ST. CHARLES SINCE 1834	**PLAN COMMISSION AGENDA ITEM EXECUTIVE SUMMARY**			
	Project Title/Address:	Pride Gas Station		
	City Staff:	Ellen Johnson, Planner		
	PUBLIC HEARING		**MEETING 6/4/19**	X
APPLICATION:		Concept Plan		
ATTACHMENTS AND SUPPORTING DOCUMENTS:				
Staff Report		Application & Plans, received 4/30/19

RE: Pride Gas Station Concept Plan

DATE: May 31, 2019

EX-1
CONCEPTUAL SITE PLAN

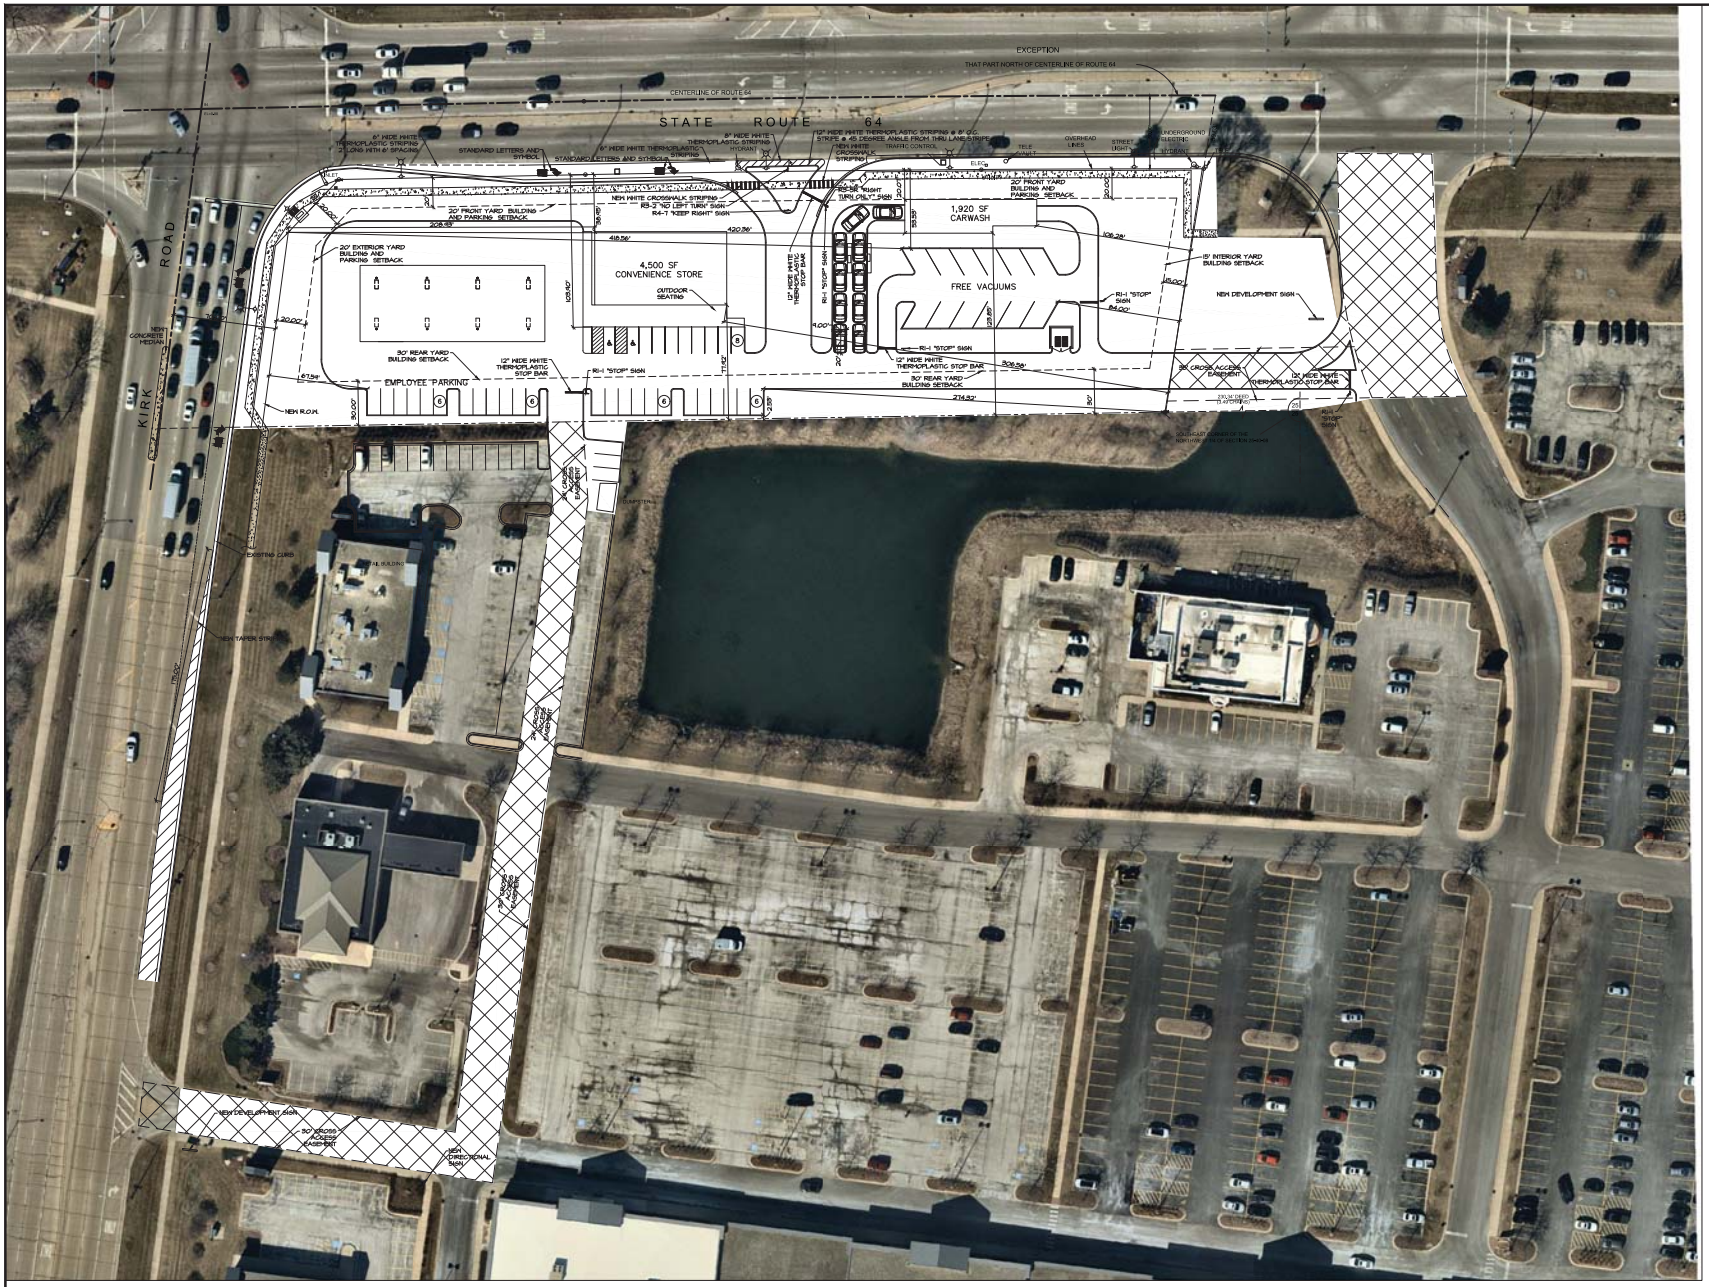
- A portion of the proposed right turn lane on Main St. is on private property rather than public right-of-way. IDOT may require the right-of-way to be extended south of the turn lane. Kirk Road is under the jurisdiction of the Kane County DOT. KDOT may require the right-of-way width to match the existing width to the south. Changes to the location of right-of-way and property lines may cause issues with conformance to building and/or parking setbacks. Setback deviations may need to be requested through a PUD.
- It appears adequate parking is provided. With 8 fuel pumps, the gas station would require 10 parking spaces based on a 4,500 sf convenience store building. However, the parking requirement will be higher due to a restaurant proposed to be located within the building. The square footage of the restaurant space has not yet been provided.

2. Fuel pumps shall be located no closer than 20 feet from any lot line and shall be located so that a vehicle using the fuel pump does not encroach into the public right of way or onto adjoining property
   - *The proposed canopy is a minimum of 30 ft. from all lot lines and at an adequate distance so that vehicles using the pumps will not encroach into the ROW or adjacent property.*

3. Gas station canopies shall be subject to the lighting standards of Section 17.22.040 (Site Lighting). Gas station canopies shall also meet all applicable setback requirements for the principal building.
   - *The proposed canopy lighting will need to meet the standards of Section 17.22.040.*
   - *The gas station canopy meets the setback requirements for the principal building.*

The proposed car wash is located up to the front setback line. Vehicle stacking is on the west side of the building with vehicles travelling east into the car wash. Vehicles exit the facility through the vacuum area.

- Landscaping will be needed to screen vehicle stacking from view from Main St.
- Stacking cannot obstruct ingress/egress to the site or interfere with vehicle circulation. The plan shows adequate space for10 stacked vehicles in two lanes without conflicting with the southern drive aisle. However, code requires 10 spaces placed in a single lane, which would conflict with vehicle circulation. A PUD deviation could be requested to allow for two stacking lanes.
- The applicant has been asked to consider flipping the direction of the car wash so that any overflow stacking does not interfere with the main driveway intersection.

Additionally, it would be preferable for the car wash to be set back further from Main St. This would help to reduce the visibility of the car wash and vehicle stacking.

- The foundation landscape bed along the west side of the convenience store will need to be increased to 5 ft. in width.
- The proposed retaining wall along the south side of the property is up to 10 ft. in height. Retaining walls exceeding 4 ft. in height require a terrace or stepping back of the retaining wall to allow for a planting area. The terrace shall be between 1/3 and ½ of the total retaining wall height, as measured from the base of the wall. The planting area shall be no less than 2 feet in width and shall be planted with a combination of turf, shrubs and perennials.

Of note is that the north elevation of the convenience store will need to comply with the design standards applicable to street facing facades, including requirements for architectural features and window transparency. This may be challenging with the building entrance and "front" on the south elevation. The applicant has indicated they intend to meet these standards, with windows on the north and west elevations and a solid wall on the south elevation. The entrance would be located on the west end of the south elevation.

The Fire Department will require a fire apparatus access road within 50 ft. of the building. The access road must be 20 ft. in width. Drives shown within 50 ft. of the car wash building are 12-13 ft. in width. The site layout will need to be modified to provide the required access.

EX-1.1
OVERALL SITE PLAN

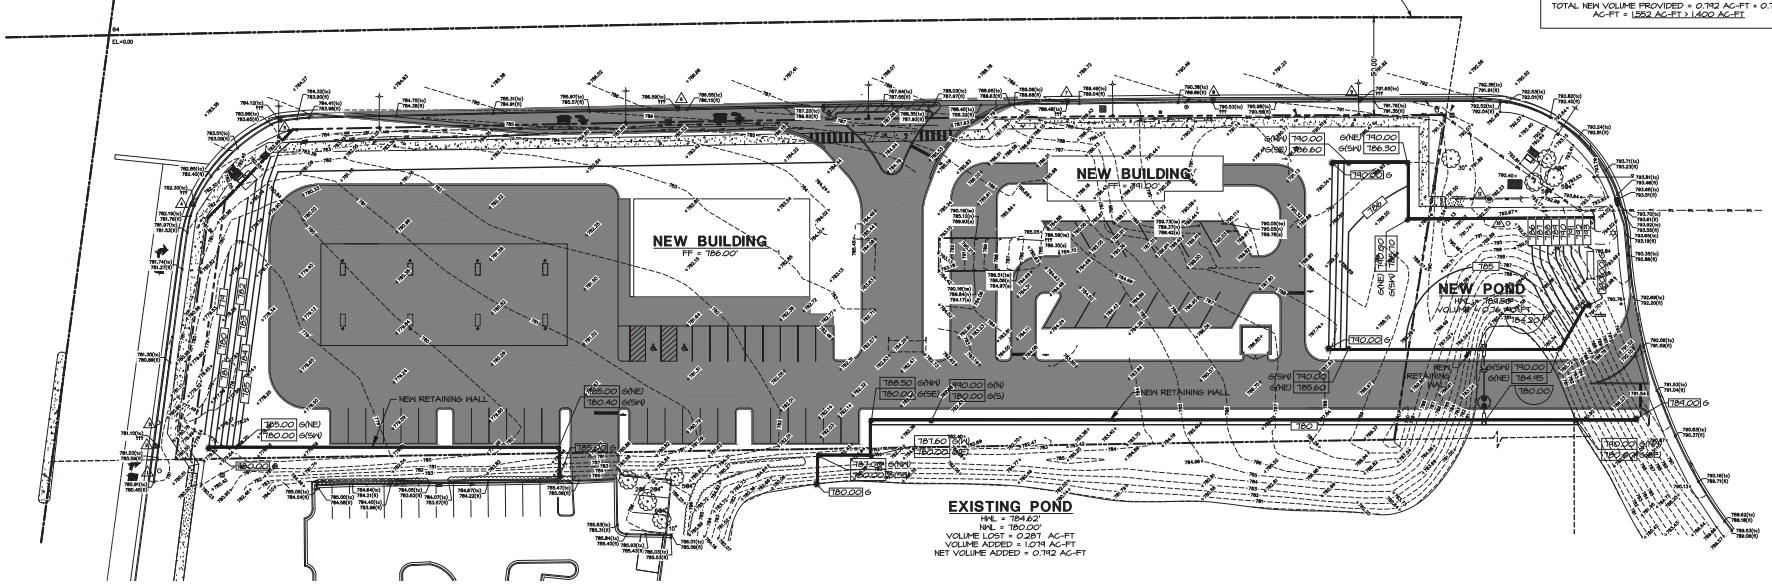
A portion of an existing detention pond that provides stormwater management for Main Street Commons is located over the proposed eastern cross-access drive. The existing pond will be modified and an additional pond will be added on the east side of the subject property. An easement agreement has been prepared acknowledging shared stormwater management between the subject property and Main Street Commons. Staff has provided the applicant with review comments regarding the new pond and need for additional retention volume and further evaluation at the time of preliminary engineering.
